U-602641  
L47-96( 09 -20 )LP  
8E.100a

Docket No. 50-461

Subject: Clinton Power Station Response to Request for  
Additional Information Related to Proposed Amendment  
of Facility Operating License No. NPF-62 (PS-95-015)

Figure 1

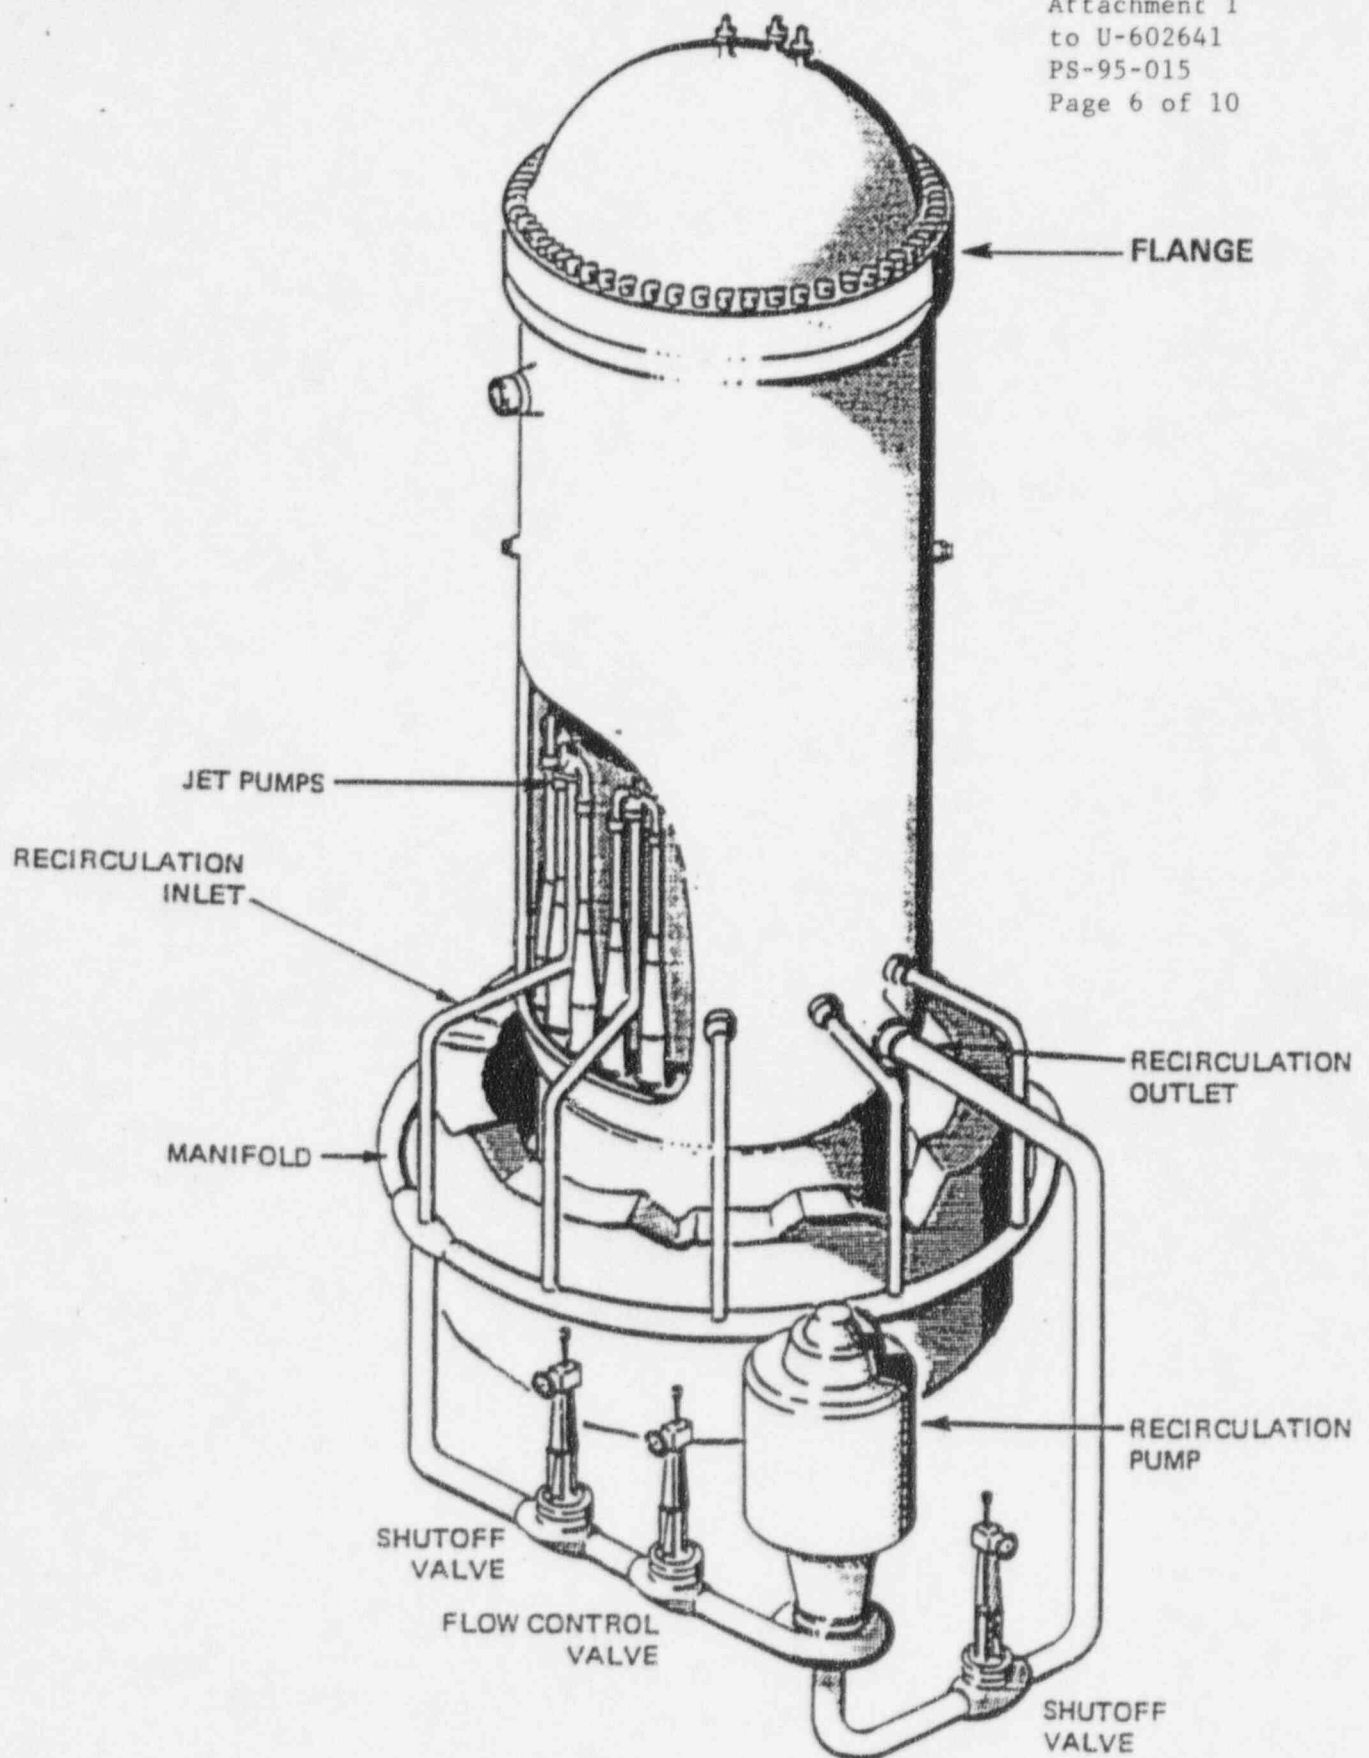
2. Identify the locations during vessel hydrostatic and leak rate testing at which the temperature measurements would be taken to:
  - (a) verify compliance with the proposed lower vessel head pressure/temperature curve, and
  - (b) verify compliance with the pressure/temperature limits established for the beltline and flange regions.

Currently, the vessel head flange, vessel shell flange, the bottom head (metal) and the bottom head drain temperatures are used to ensure that the entire vessel is at the required test temperature. Figures 1 and 2 depict the general arrangement of the reactor vessel, recirculation piping, and internal structures. The region of the vessel that is embrittled by neutron irradiation, i.e., the beltline region, is adjacent to the core and is heated by the water in the annulus (wherein the jet pumps are located). During leak testing, the vessel is water solid and natural circulation provides mixing within the system. The measurement of the temperature at both ends of the vessel adequately ensures that the beltline temperature is known for the purposes of meeting the P-T limits during leak testing.

Regarding verification of compliance with the proposed bottom head P-T curve [Question 2(a)], the bottom head metal temperature and the bottom head drain temperature will be used to verify compliance with the limits imposed by the bottom head curve. These two indications are already used in conjunction with meeting the conditions specified by the existing P-T limits curves. The lowest of the two temperature readings will be used for comparison to the proposed bottom head P-T curve to ensure that the vessel bottom head region is within the required temperature limits during vessel hydrostatic and leak rate testing.

In response to Question 2(b), the vessel head flange, the vessel shell flange, and the reactor recirculation loop suction temperatures will be used to ensure compliance with the P-T curve applicable to the beltline and flange regions.
